**Rezoning Transportation Analysis**  
**Petition Number: Insert Zoning Petition #2020-181**  
*General Location Identifier: 11122105*

**Revision Log:**

Date	Description
01-21-21	First Review (WB)

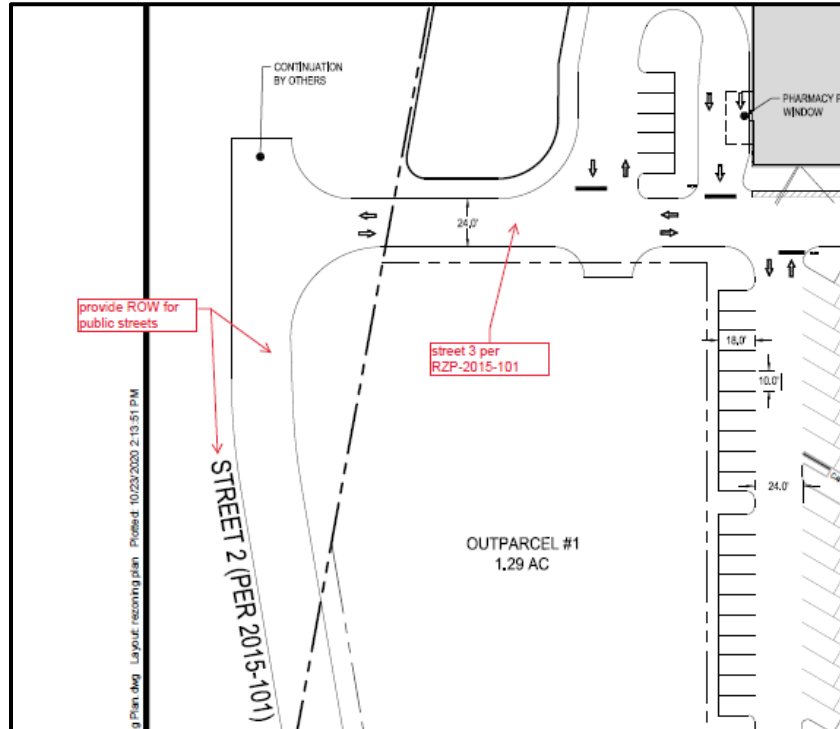
Label and dimension the curb and gutter from the centerline for each road on the site plan.

A Traffic Impact Study is necessary for the complete review of this petition due to the site generating more than 2,500 daily trips.

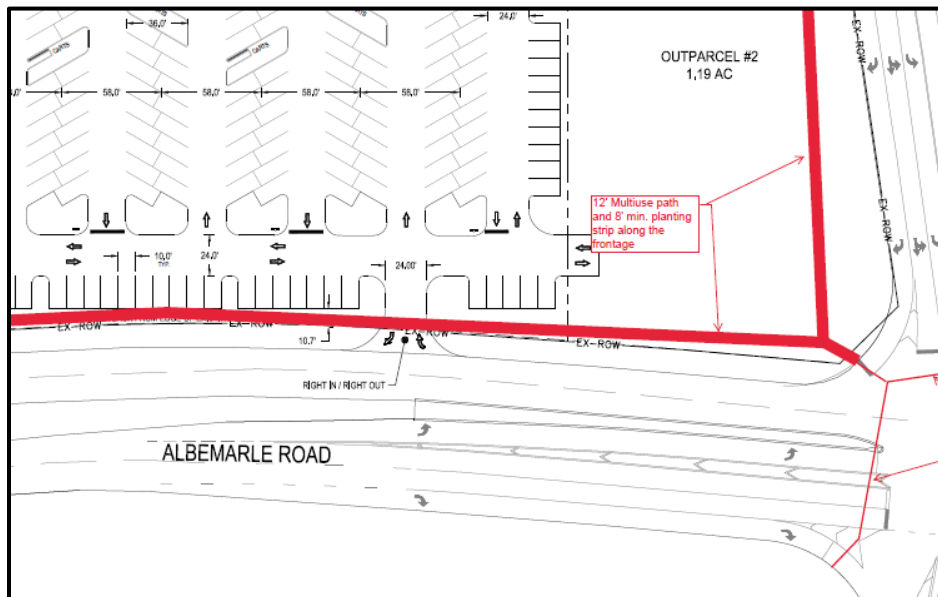
3. Site plan and conditional note(s) revisions are needed to commit to constructing a 12' multi-use path with an 8' planting strip along the site's frontage in accordance with the Charlotte BIKES and Charlotte WALKS Policies. The petitioner should coordinate with the developer of Approved Rezoning Petition 2020-007 to ensure that intersection improvements provide continuity between the multi-use path and planting strip on both sides of Rocky River Church Road. The site plan shall label and dimension both items from the back of curb and gutter and road centerline.

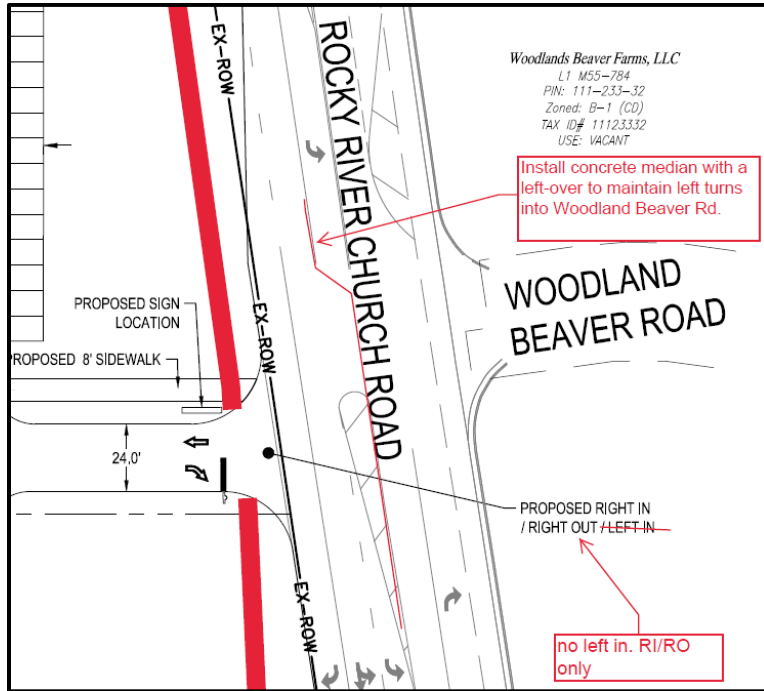
2. Revise site plan and conditional note(s) to commit to constructing a concrete median with a left-over on Rocky Rover Road to maintain left turns into Woodland Beaver Rd and prevent left turns into the site's southmost access into the site.

5. Site plan and conditional note(s) revisions are needed to commit to providing intersection improvements to accommodate pedestrian and bicycle crossings at the Albemarle Road and Rocky River Church Road Intersection. These improvements shall include accessible ramps, channelization islands and all associated infrastructure modifications needed to provide a safe route for both bicyclists and pedestrians and align with those improvements found and approved as part of RZP 2020-007.

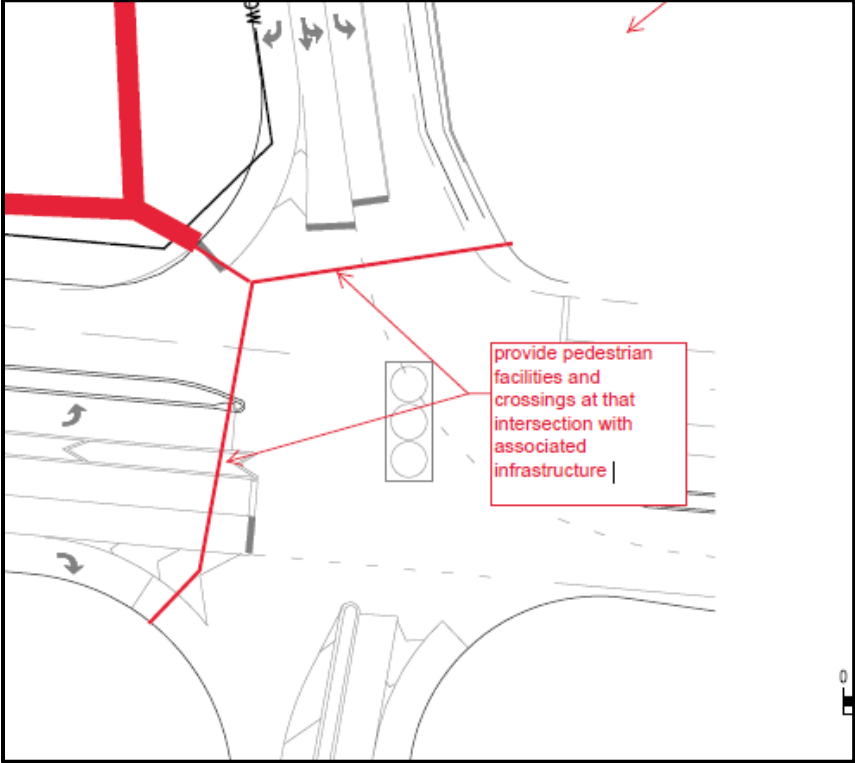
- 6. A site plan note(s) specifying dedication and fee simple conveyance of all rights-of-way to the City before the site's first building certificate of occupancy is issued is needed. CDOT requests rights-of-way set at 2' behind back of sidewalk where feasible.
- 7. A site plan note specifying that all transportation improvements will be approved and constructed before the site's first building certificate of occupancy is issued is needed. The petitioner may phase transportation improvements if said improvements and phasing are explicitly described in site plan notes.
